REVISED RESPONSE TO REQUEST FOR ADDITIONAL INFORMATION

APR1400 Design Certification

Docket No. 52-046

RAI No.: 208-8245
SRP Section: 03.08.03 – Concrete and Steel Internal Structures of Steel or Concrete Containments
Application Section: 03.08.03
Date of RAI Issue: 09/14/2015

Figure 2. Line of Sight from Sparger

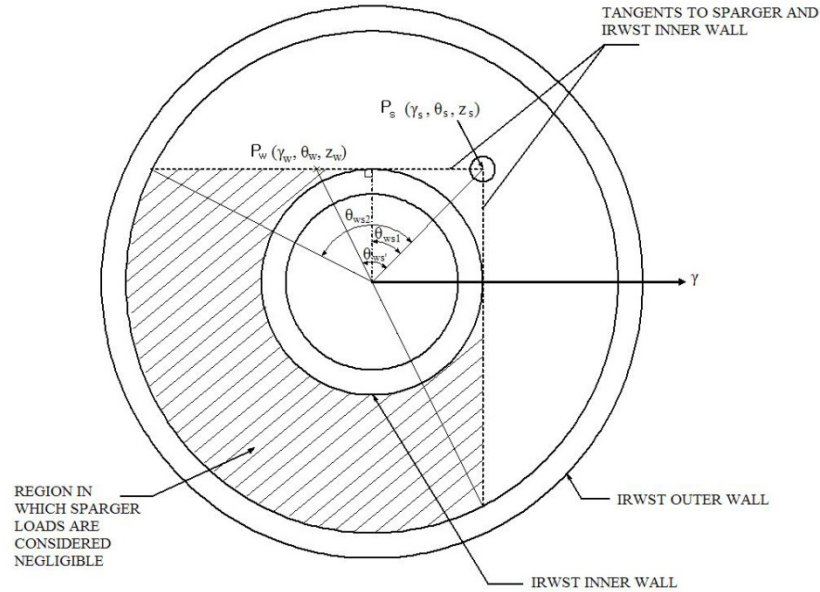
- c. How the total pressure transients on the walls and floor were developed based on the cases identified in item (b) above (a figure showing the pressure distributions on the walls and floor should be provided).
- d. How the dynamic impact factor, discussed in DCD Section 3.8A.1.4.3.1.3, was determined, and explain why applying this as a static load is considered conservative.

Air bubble discharge loads from a particular sparger are considered to act only on the boundaries which can be "viewed" from the sparger bubble with direct line of sight as illustrated in Figure 2. To find the shade area, angle θ_{ws} on the line of the tangents to the sparger and inner wall can be expressed as

$$\theta_{ws} = \pm \left[\cos^{-1} \frac{r_{in}}{r_s} + \cos^{-1} \frac{r_{in}}{r_w} \right]$$

The shade regions between these two angles are not in direct line of sight of the depicted sparger discharge and, therefore, no load acts on these boundaries due to this sparger discharge.
